Staff Summary Report

Development Review Commission Date: 08/14/07

SUBJECT: Hold a public hearing for a Zoning Map Amendment and a Development Plan Review for **CAMPUS TOWERS** located at 1215 East Orange Street.

DOCUMENT NAME: DRCr_Campus-Towers_081407

ATTACHMENT 29

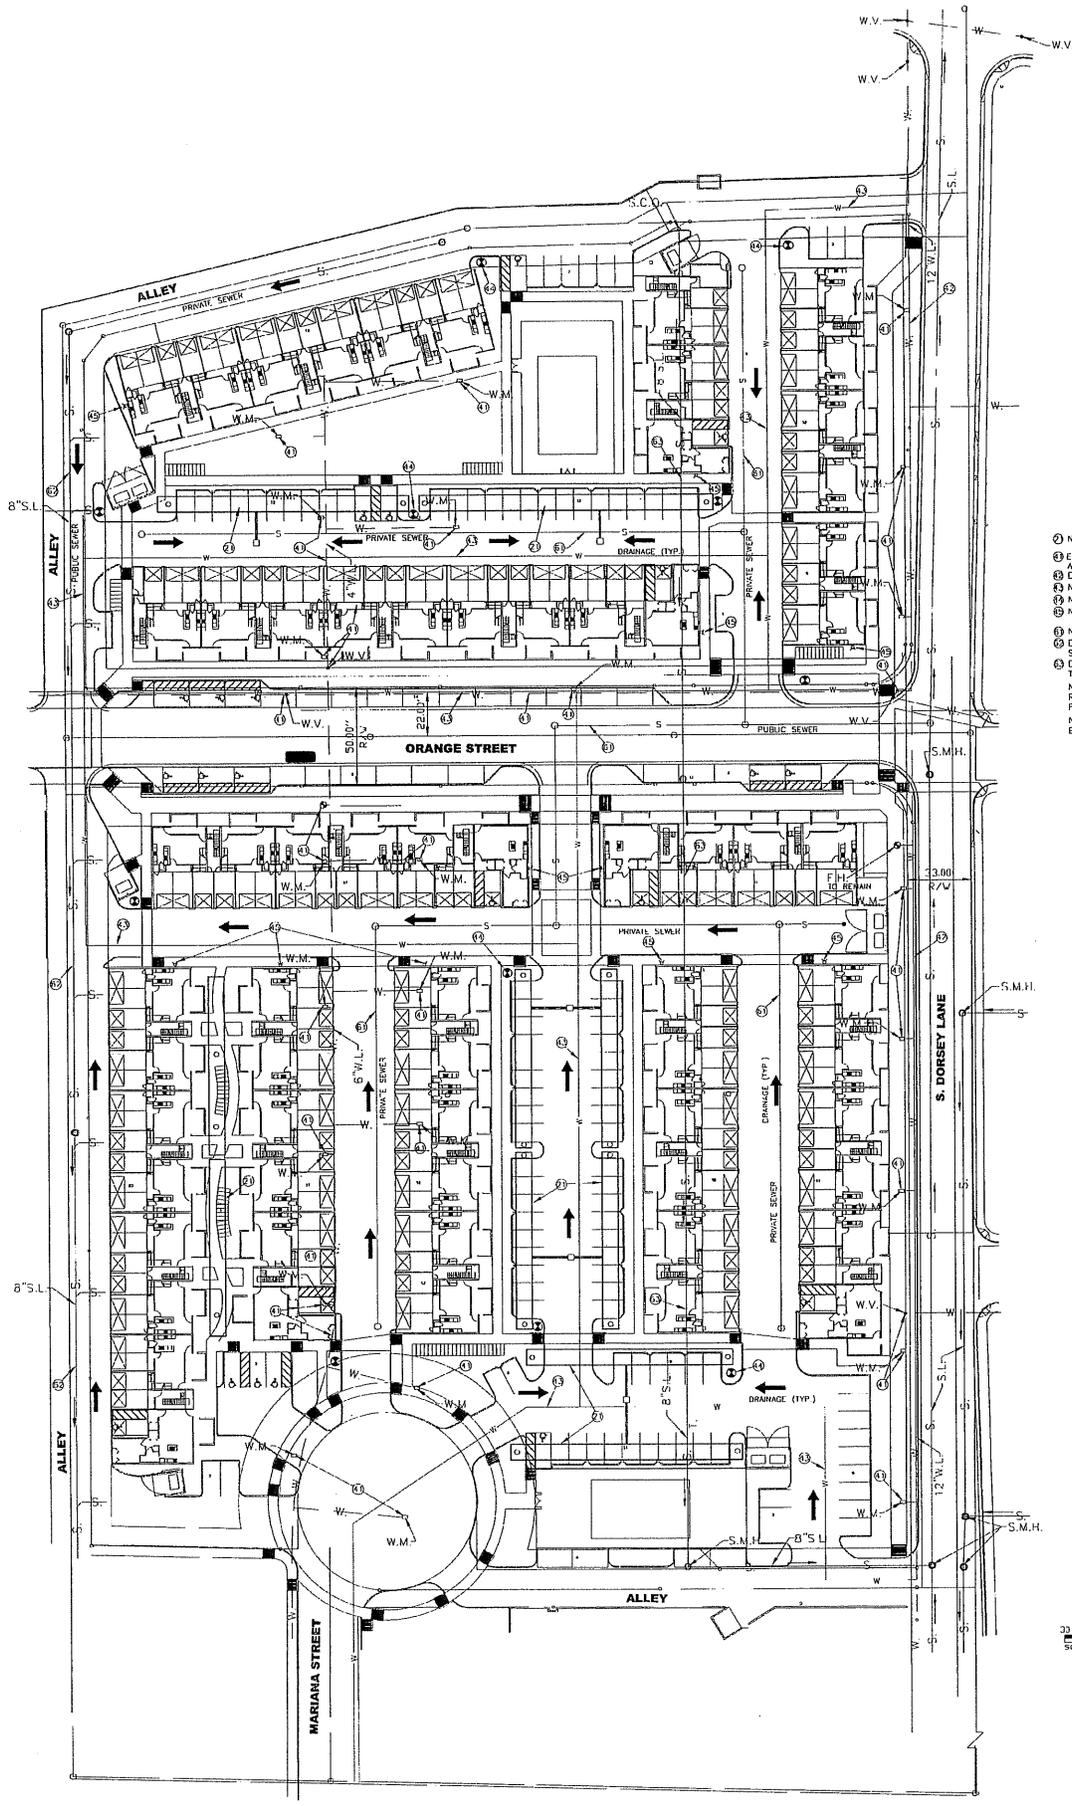
28. Provide additional canopy trees throughout development. Refer to Site Plan Review mark-up, dated 6/20/07, for graphic description of this requirement. In particular, provide required parking landscape island canopy trees in all locations, provide canopy trees along west of Dorsey and on both sides of Orange, and provide a canopy tree row on the north side of the Parcel A triangular green.

31. Provide trees of minimum 24" box installation size in lieu of 15 gallon size indicated in the plant legend.
32. The following tree substitutions are required: *Parkinsonia* 'Desert Museum' for *Parkinsonia floridum*; and *Phoenix dactylifera* (minimum 20' brown trunk, diamond cut) for *Chamaerops humilis*. Consider salvage of existing *Phoenix dactylifera* in project area prior to site demolition and reuse of these trees in Campus Towers.
